**Subject:** San Mateo Park Elementary School HVAC Replacement  
San Mateo - Foster City School District  
Aedis Project No. 2021011.08  
DSA Application #01-120214

### ADDENDUM NO. 1

San Mateo Park Elementary School HVAC Replacement  
San Mateo – Foster City School District  
Aedis Project No. 2021011.08

SHEET # **AD1-  
MP6.02**

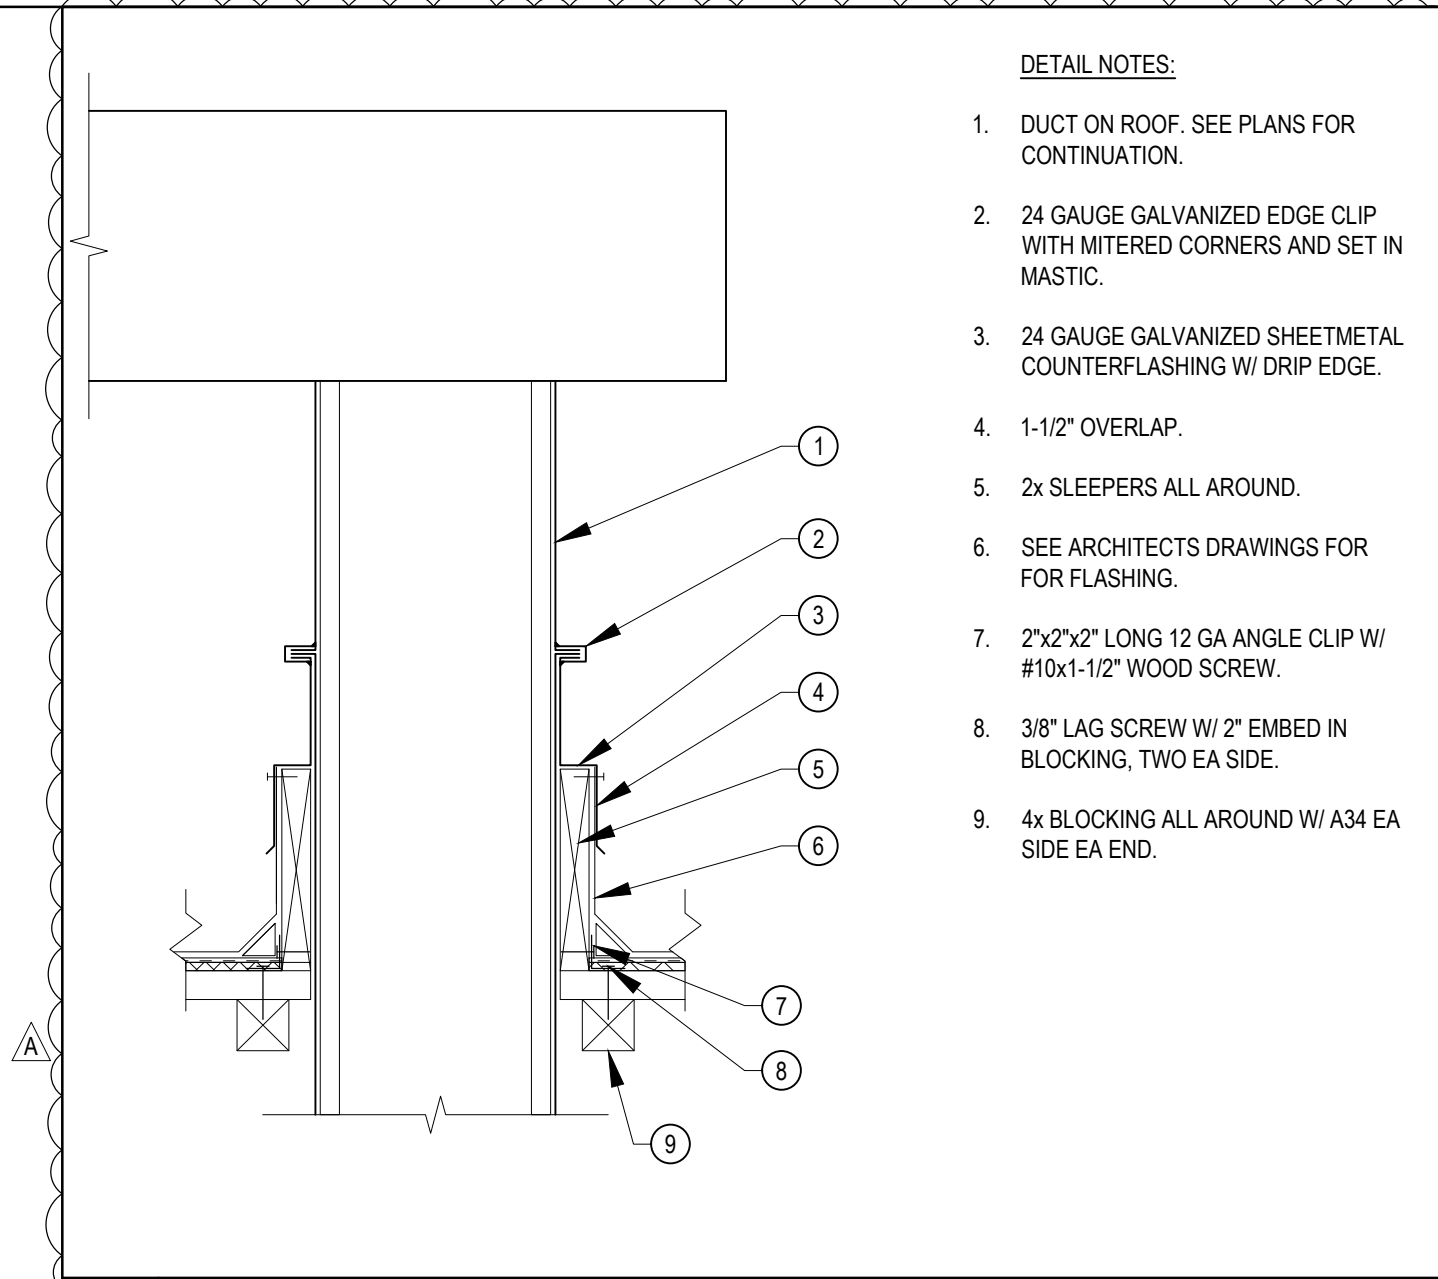
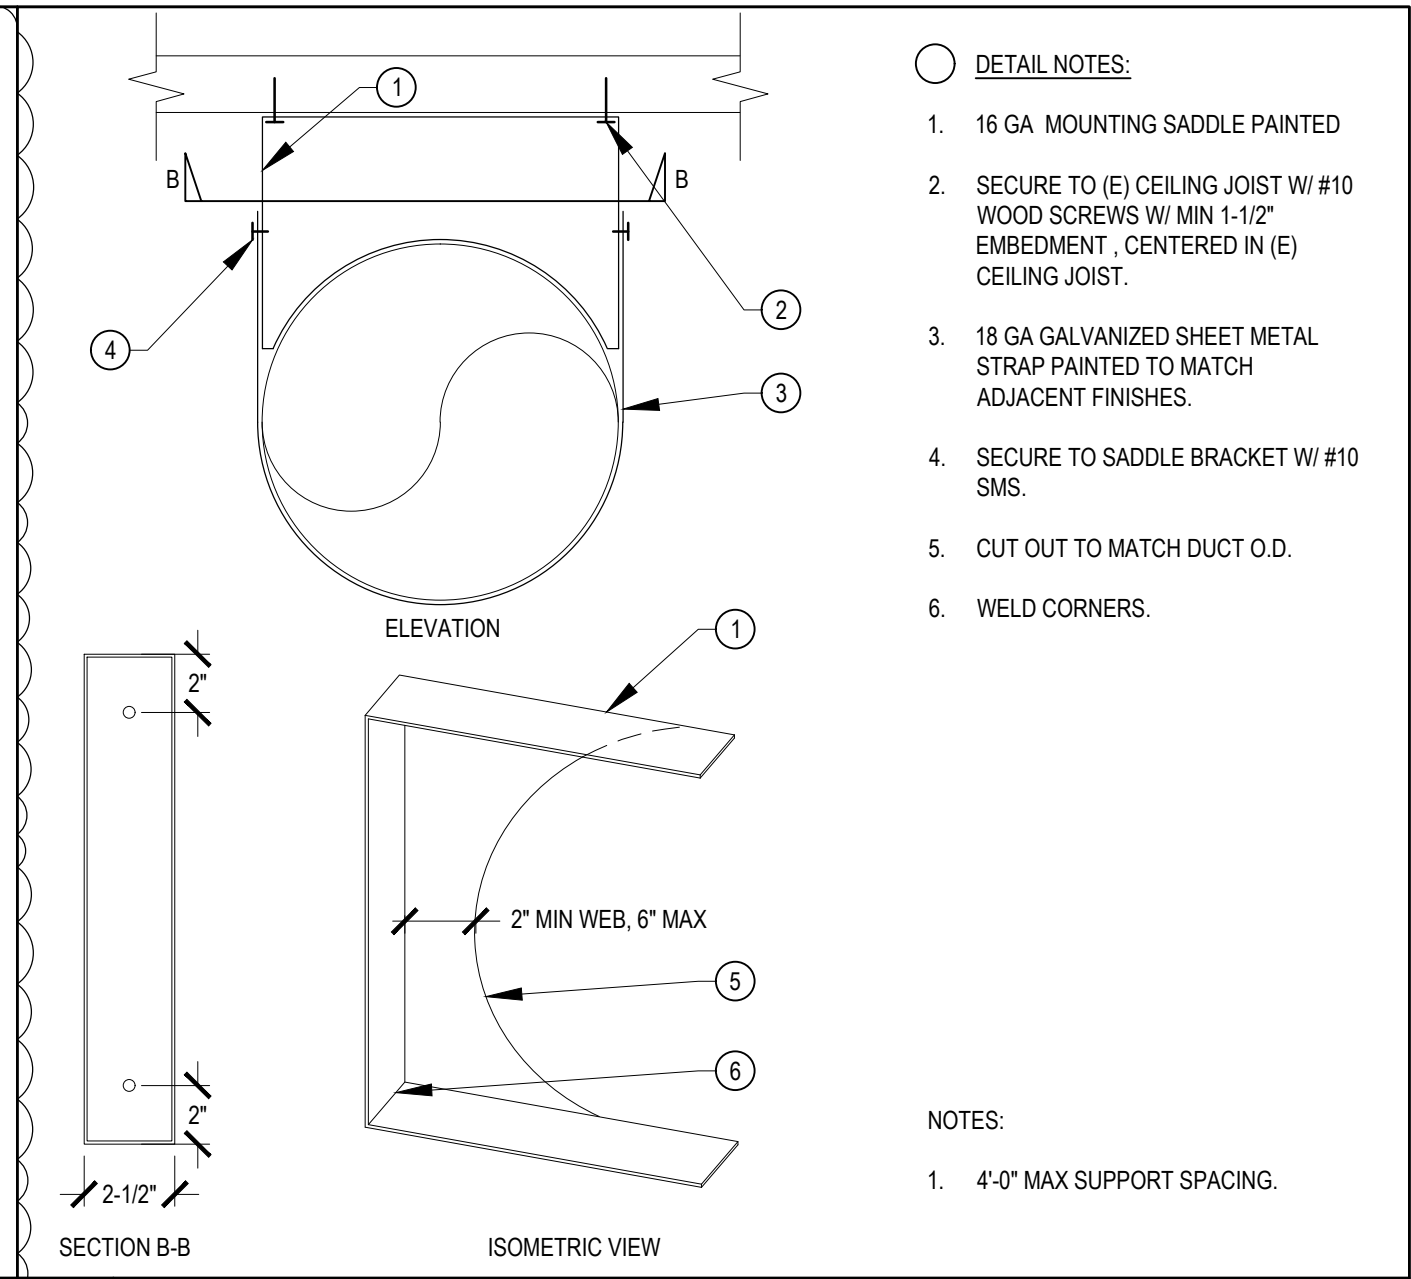
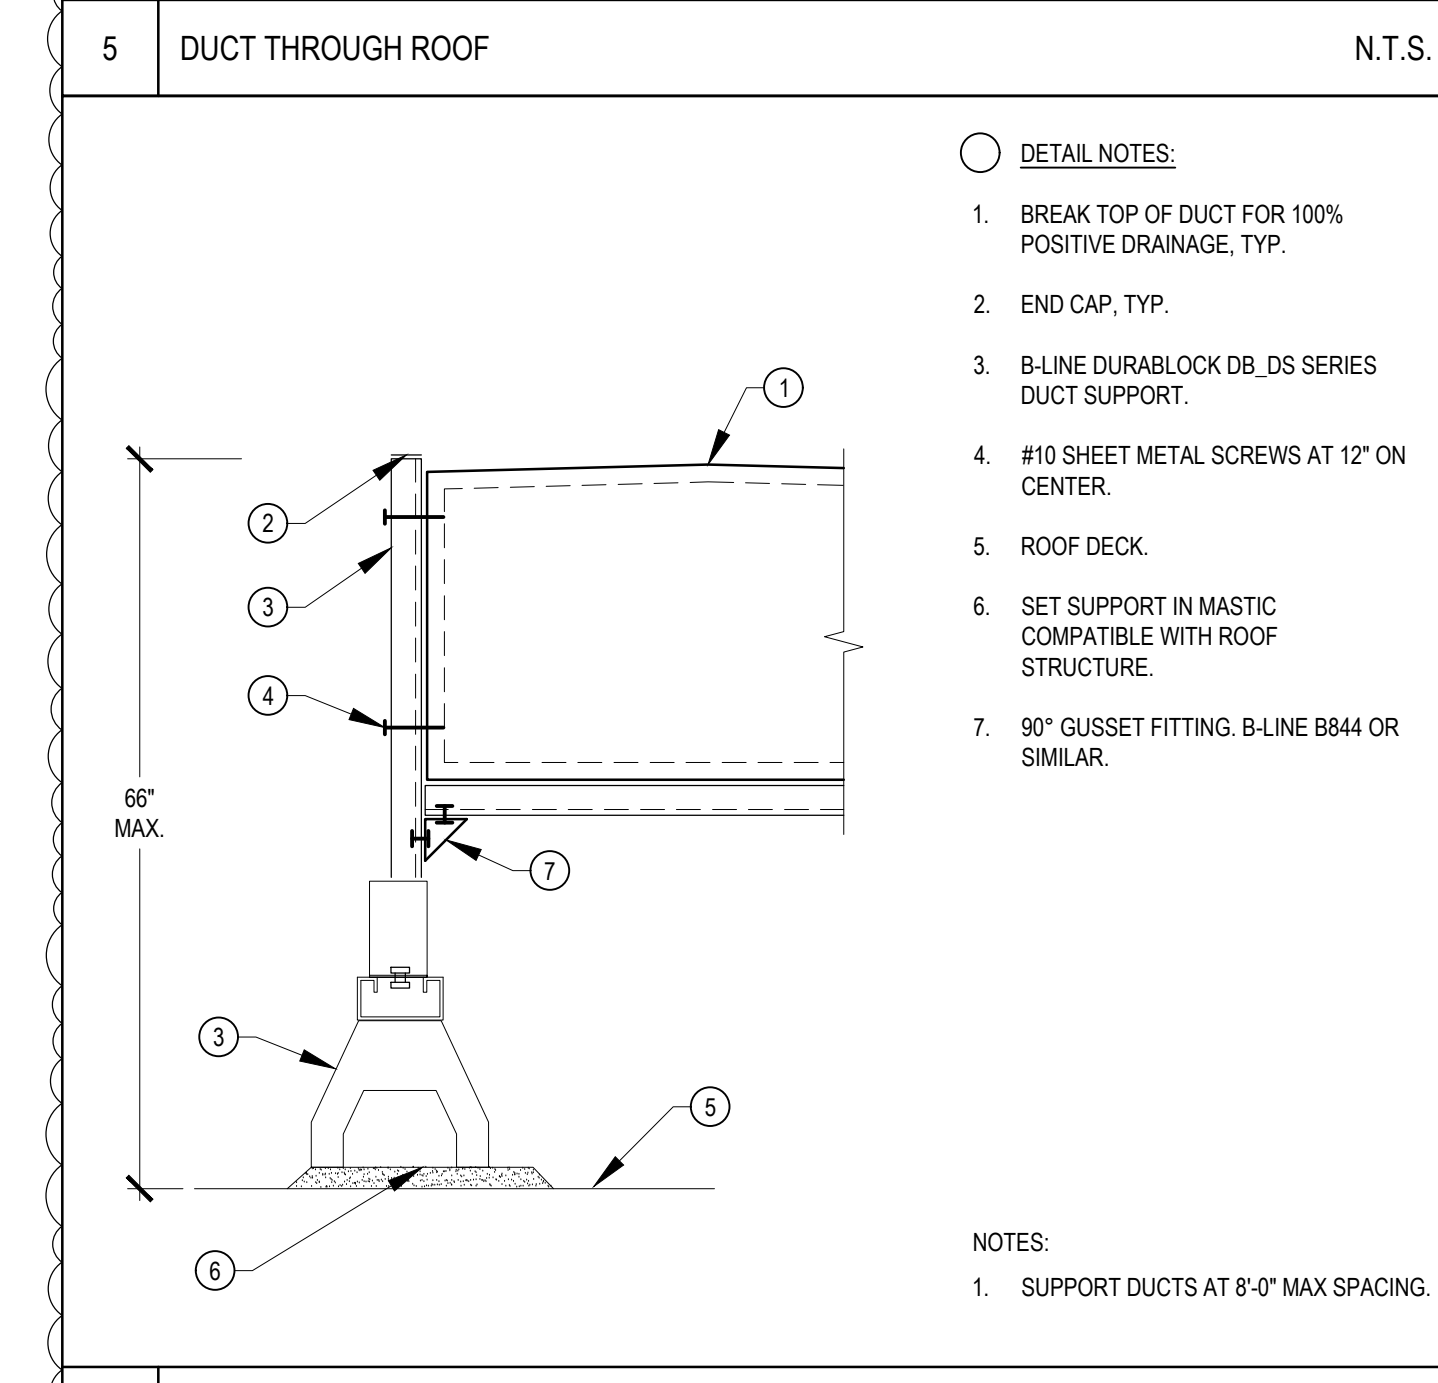
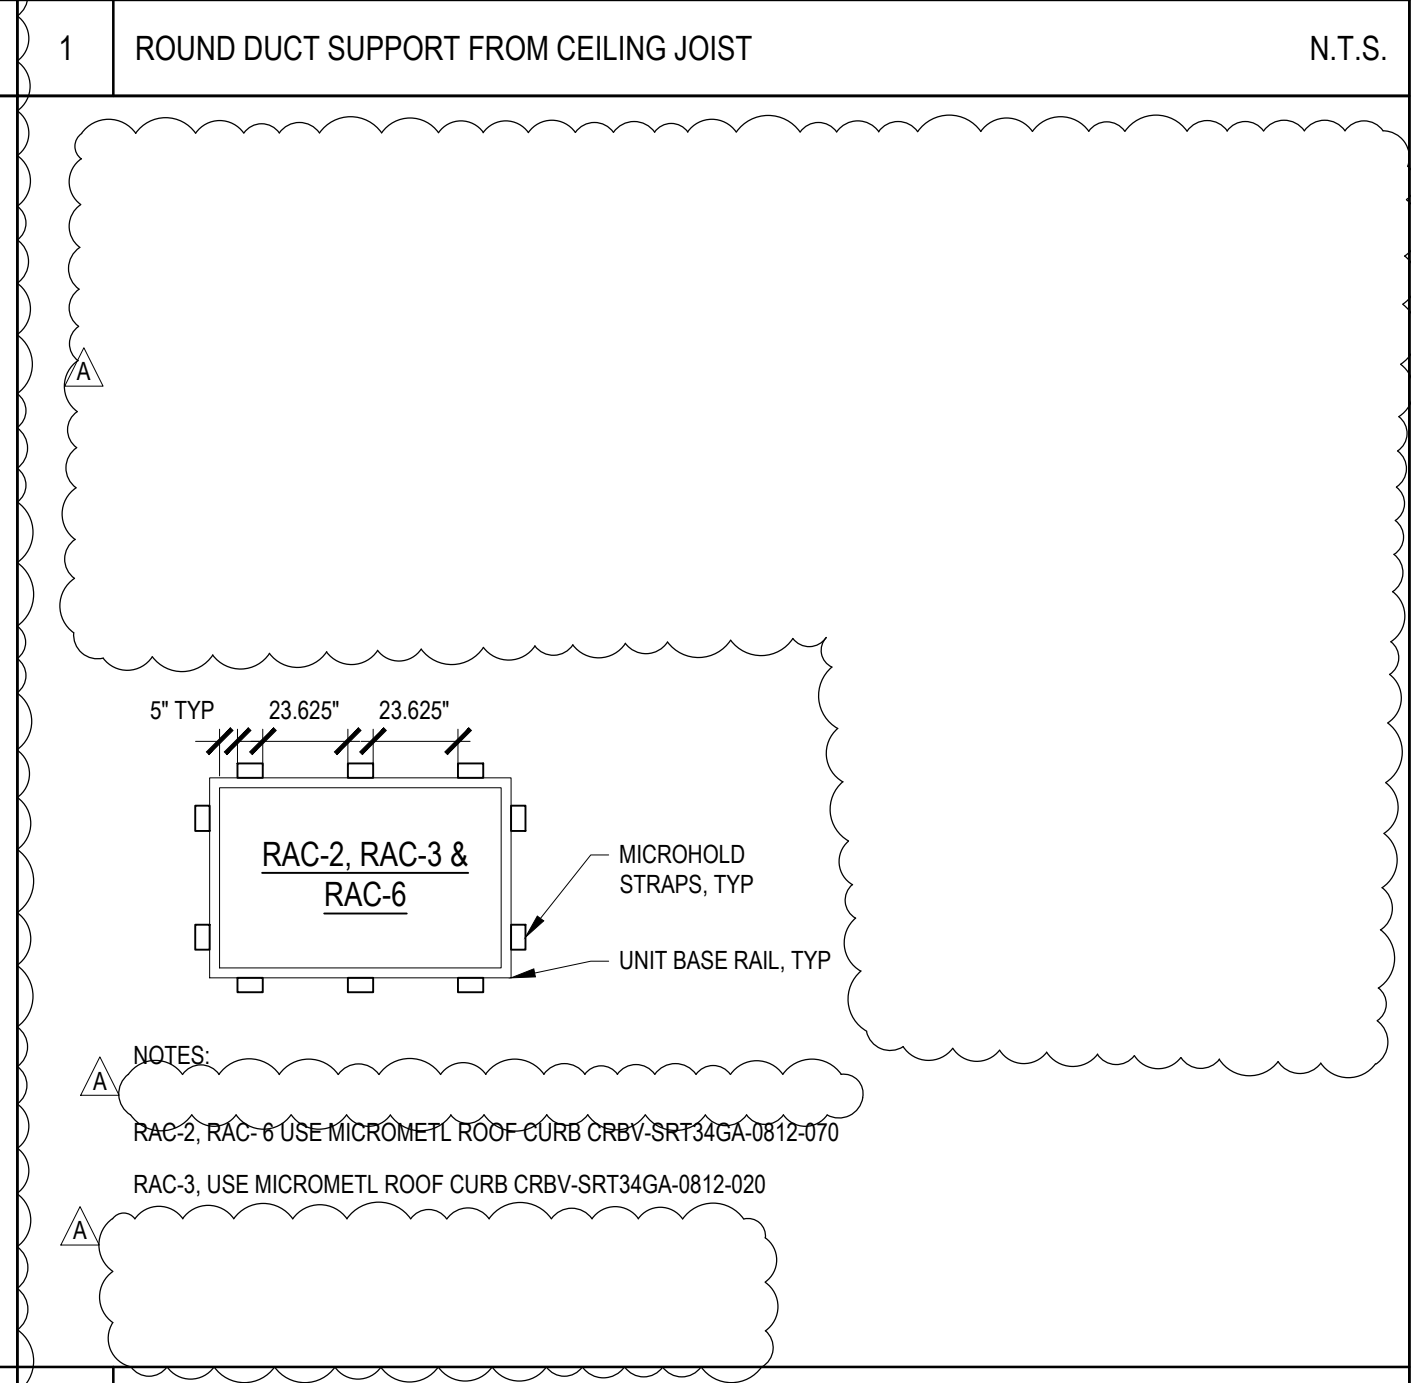
- Revise: Detail 2 – Curb Plan View Microhold Locations as shown per AD1-MP6.02
- Add: Details 3 through 7 as shown per AD1-MP6.02
